ADDENDUM NUMBER: Addendum - One

PROJECT TITLE: Milwaukee County Parks Department
VETERANS PARK SHELTER
Site Number: 794
Building Number: 1505
750 North Lincoln Memorial Drive
Milwaukee, Wisconsin 53202

PROJECT NUMBER: P167-10422

DATE OF ADDENDUM: June 7, 2013

DATE: 08/06/2013
 PROJECT: P187-10422
 SHEET NO: 7/4
 SHEET NO: 1502
 SHEET NO: ADD.2-1

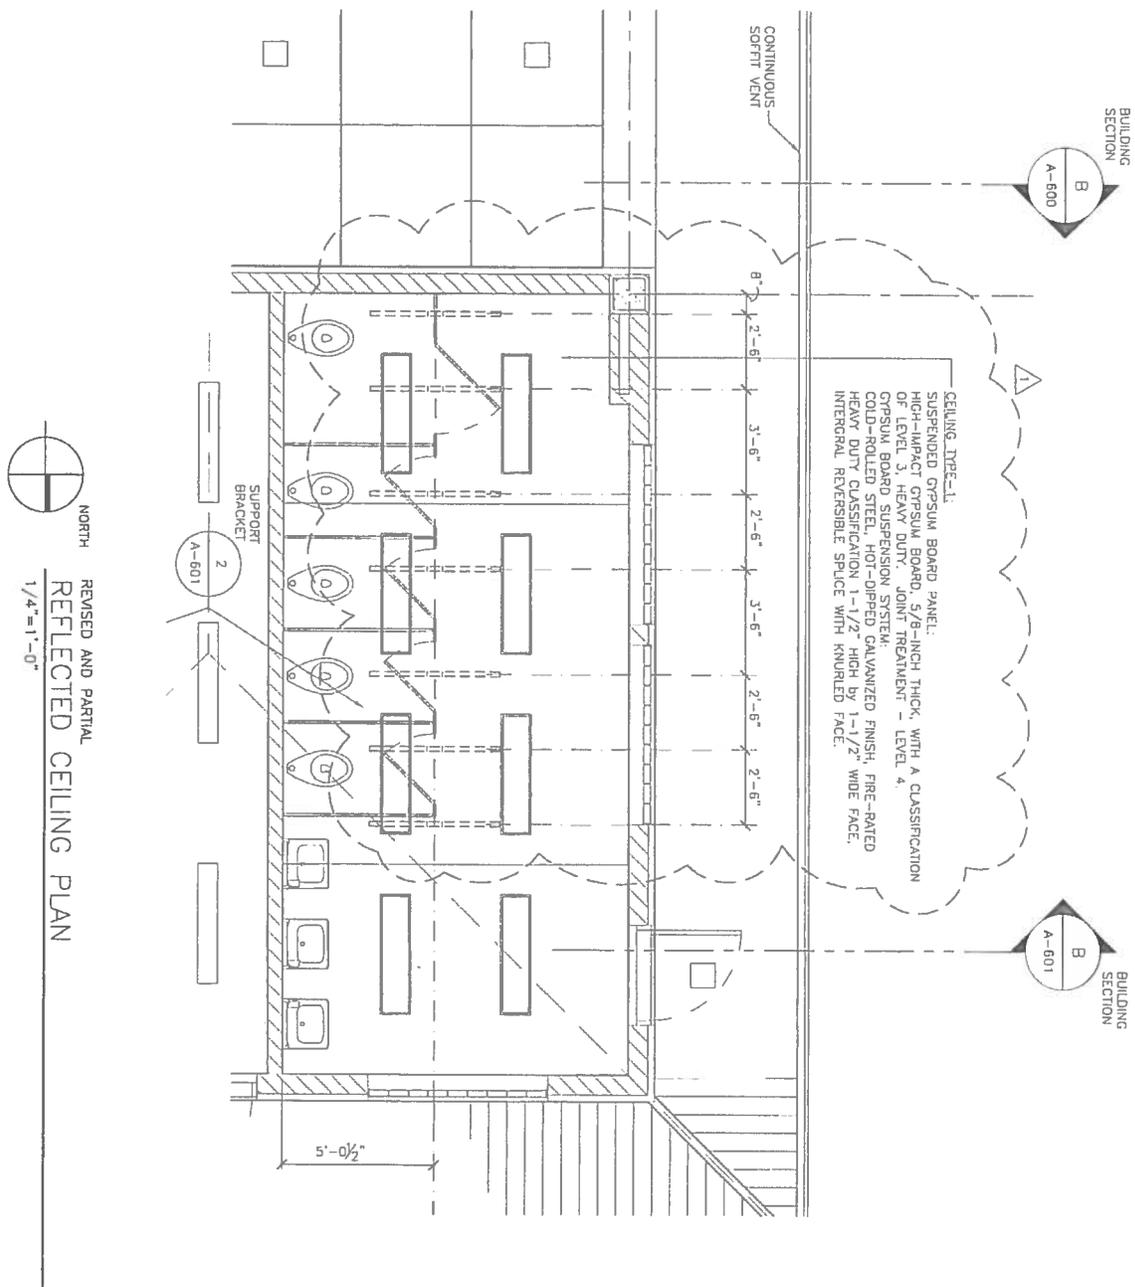
Revised toilet partition support bracket locations in Women s Toilet Room – 102, as detailed on attached drawing ADD-2.1.

DATE: 01/08/2013
 PROJECT: P-167-10422
 SITE NO: 784
 SHEET NO: 1505
 ADD.2-2

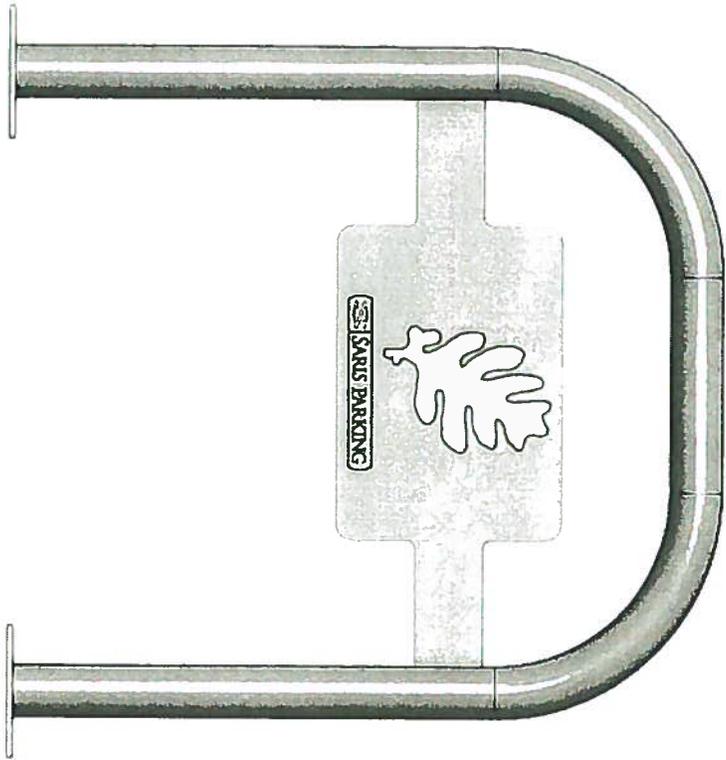
Revised EGRESS WIDTH CALCULATIONS, see attached drawing ADD-2.2.
Revised OCCUPANCY LOAD CALCULATIONS, see attached drawing ADD-2.2.
Revised MINIMUM NUMBER OF REQUIRED PLUMBING FIXTURES, see attached drawing ADD-2.2.

BICYCLE RACK
 Saris Brand – Series 2112
 Milwaukee County Parks Logo

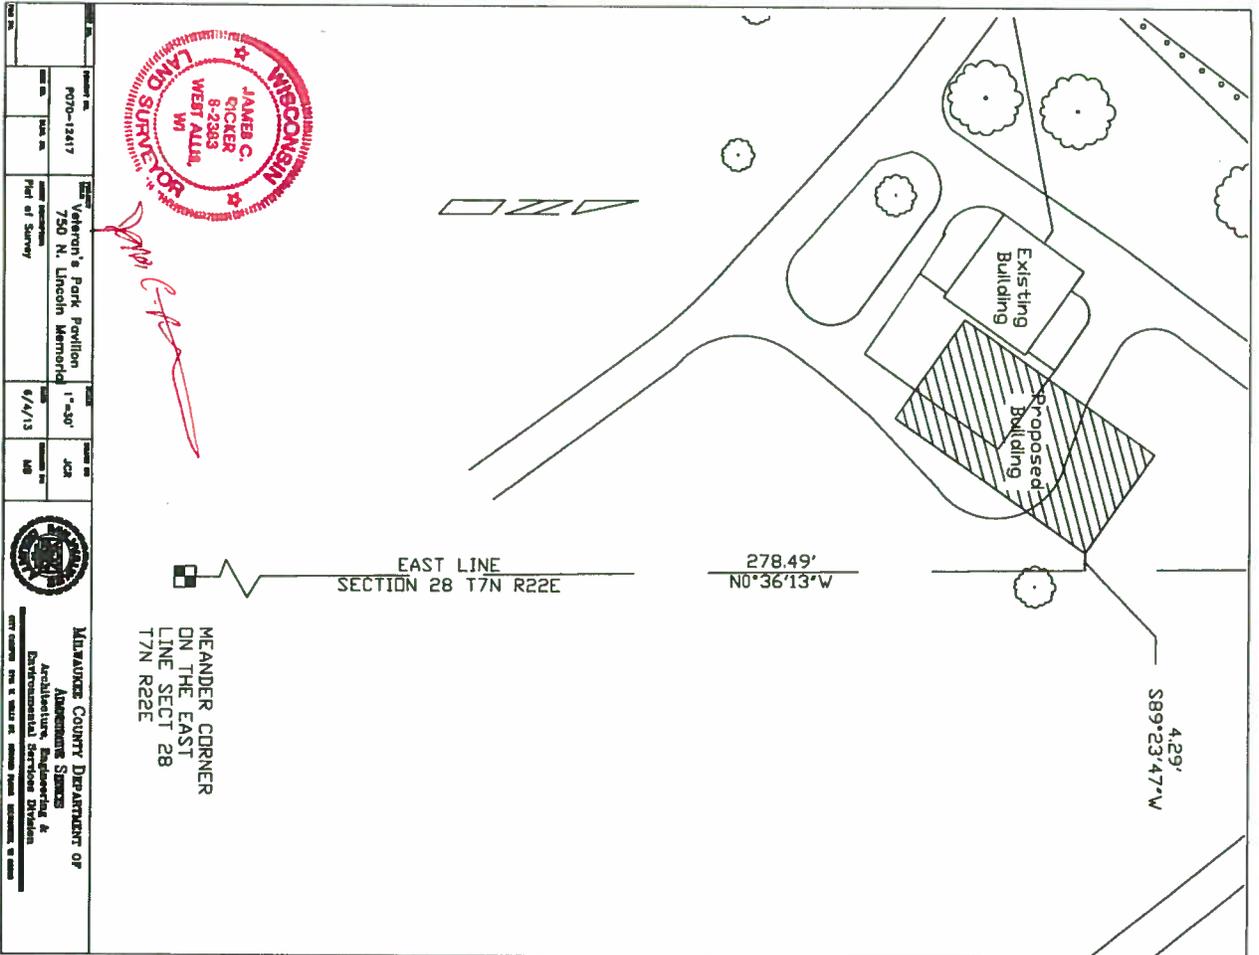
- A. Manufacturers:
 - 1. Saris Brand bike docks.
 - a. Provide one (1) Saris Brand – series 2112 with Milwaukee County Parks logo (see attached drawing) and in-ground mount. Color to be selected by Owner.
 - b. Provide two (2) Saris Brand – series 2112 with in-ground mount (logo not included). Color to be selected by Owner.
